Municipal Class Environmental Assessment Study: Water and Wastewater Servicing in the Nobleton Community

Public Consultation Centre 3 Summary Report

July 20, 2021 Zoom Webinar

Prepared for: The Regional Municipality of York

Figure 1: A map illustrating the study area, service area, and existing Regional infrastructure in the Community of Nobleton.

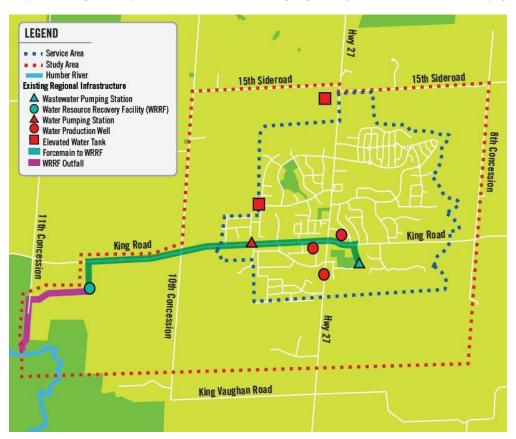
Q: Will 13755 York Regional Rd 27 be part of the expansion? From the map, I see it right on the edge near Hwy 27 and 15^{th} Sideroad.

Submission Type	Comment/Issue
Email	I notice that the virtual presentation and question period are not yet online. Can we
	therefore have an extension to the comment period, currently closing on August 4th?
Email	Could you please send us the presentation slides for files?
Email	The map on page 3 is the only map showing both the service area and the study area.
	It does not show the location of all of the water and wastewater sites discussed later
	in detail. A complete map would have been helpful.
Email	The evaluation process mentions financial criteria, yet we are advised in the Q and A
	that there are no capital cost estimates. How could you rank the alternatives without
	some costs? More on this in my comments on the Q and A.
Email	On the wastewater solution, I couldn't tell from the map provided whether additional
	land is required for the storage tank. If so, that could slow the project and the pipe

A: This property is outside of both the project's service area and study area, according to the
map on the <u>project webpage</u>. Though not guaranteed, future water planning changes or studies
may extend to that address however, it is not included in the study today.
